Service Technical Information

MODEL NO.	XR-MD85 EZ
SUBJECT	Tape stop at FM recording

REF.No. :G - 99 - 047 - E0

DATE :01. NOV. 1999

MAIN C.B. PATTERN SIDE

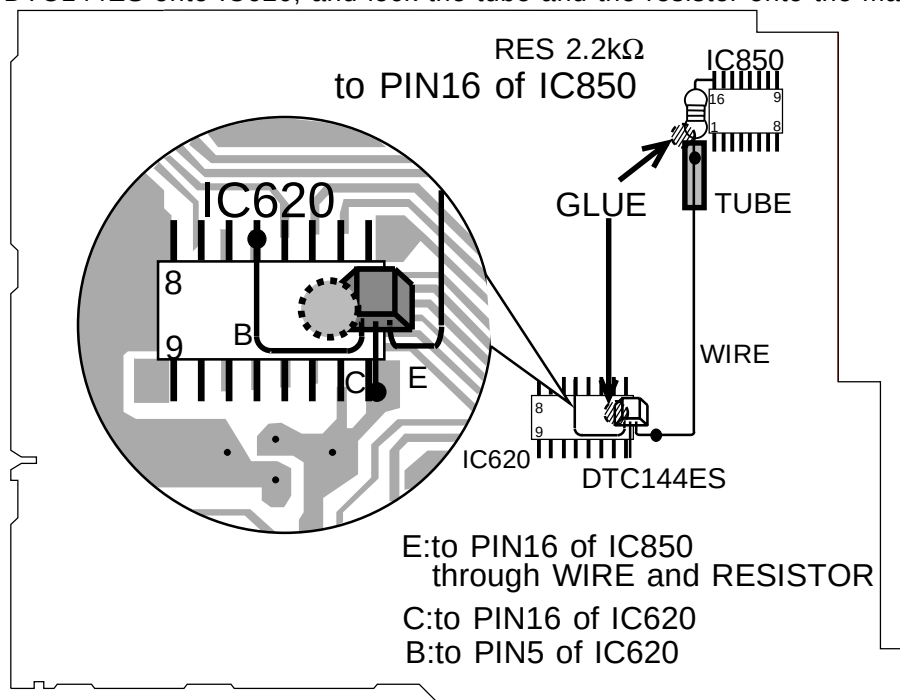
A tape stops in approximately 5 minutes after starting recording of an FM program on tape, using the model in question.

This problem occurs when an FM signal includes RDS signal.

1. Solder the base terminal of DTC144ES to pin 5 on IC620, and solder the collector terminal of DTC144ES to pin 16 of IC620.
2. Solder the emitter terminal of DTC 144ES to the wire, and let the wire in the tube.
3. Solder an end of the wire to the resistor.
Solder the other end of the resistor to pin 16 of IC850.
4. Lock DTC144ES onto IC620, and lock the tube and the resistor onto the main C.B. with glue.

After taking the above actions, RDS indication will not be updated during REC operation on tape.
